Service Campaign Bulletin

Campaign No. 2012120004, January 2013

SUBJECT: **Models 212, 218 with Engine M157, Model Year 2012**
Update Injector Coding

Figure 1 (shown on engine 278)

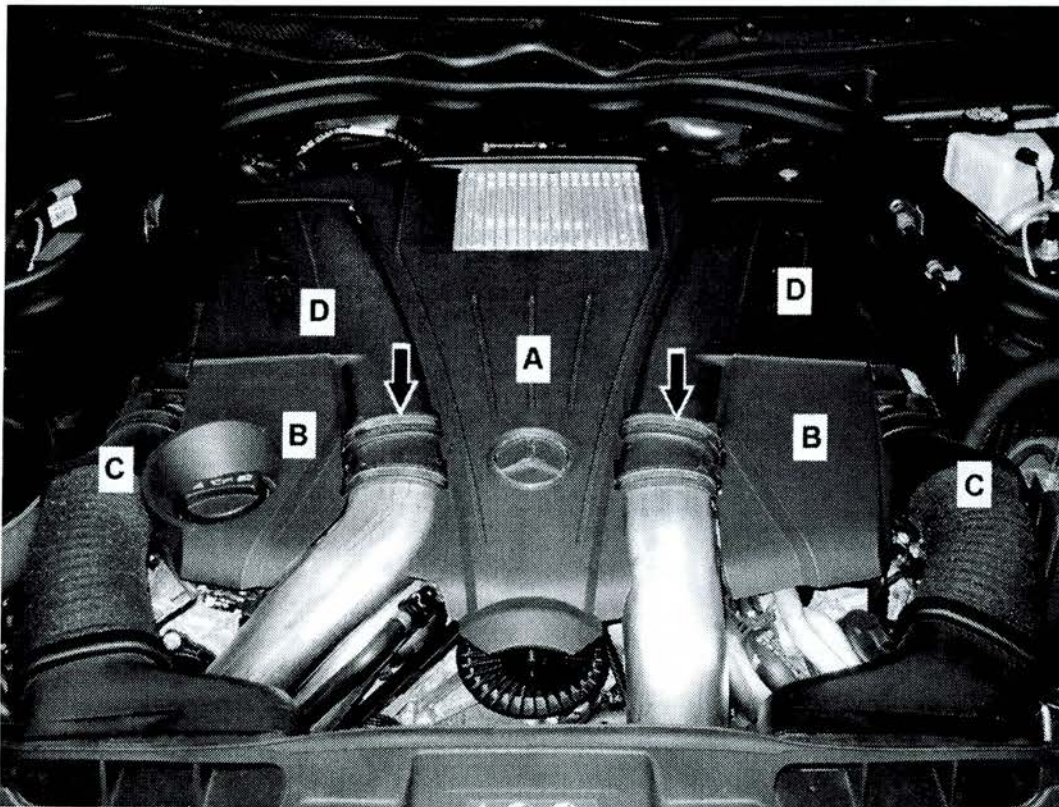
- Use DAS/Xentry 11/12 with all associated patches or higher.
 - Follow the steps exactly as described in DAS/Xentry.
 - Connect battery charger (battery voltage >12.5V).
1. Remove air filter housing to view injector codes:
 - Pull up on engine covers (A, B, Figure 1) to unclip from engine mounting points then remove.
 - Disconnect air intake duct (C) from air cleaner (D).
 - Loosen hose clamps (arrows) then disconnect charge air ducts from air cleaner (D).
 - Pull up on air cleaner (D) to unclip from engine mounting points and place to one side.
 - Remove insulation located over fuel rail.

Figure 2

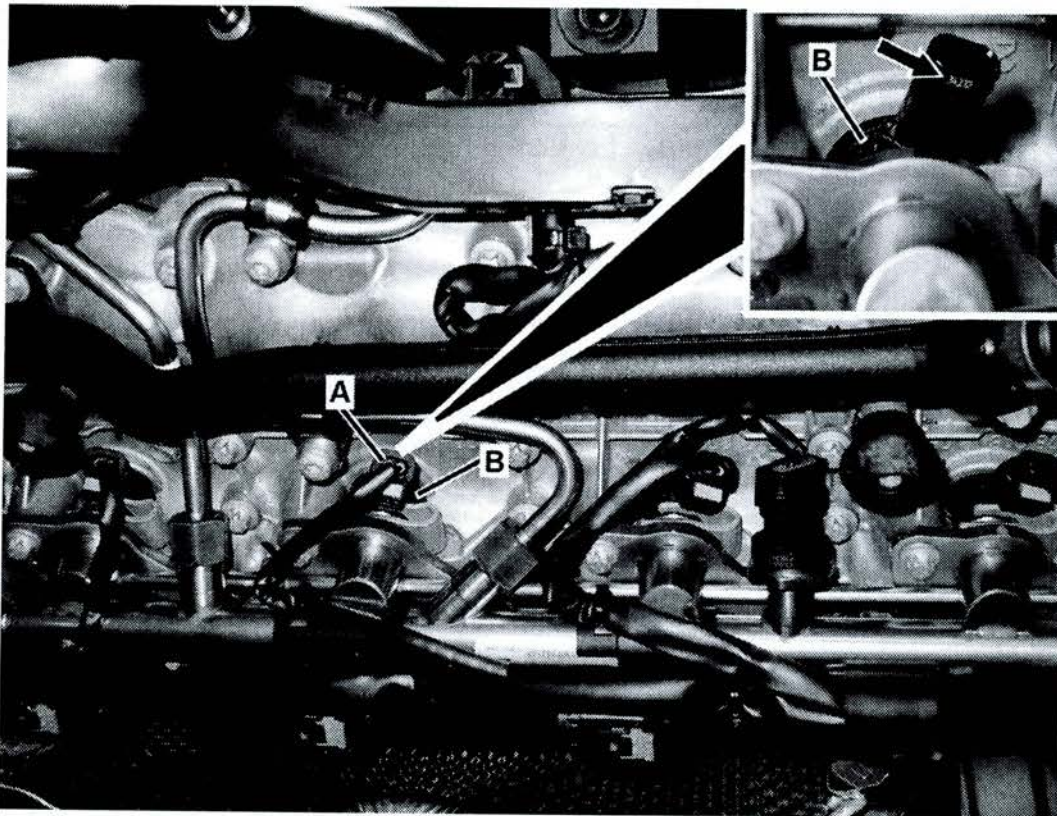
- Injector code (arrow, Figure 2) can be read by disconnecting engine harness connector (A) from injector (B).
- If injector code (arrow) found on each injector, is **different** from injector code indicated on Star Diagnosis screen, proceed with injector coding (follow-on screen instructions). If injector code (arrow) found on each injector is the **same** as injector code on Star Diagnosis screen, injector coding is **not** required.
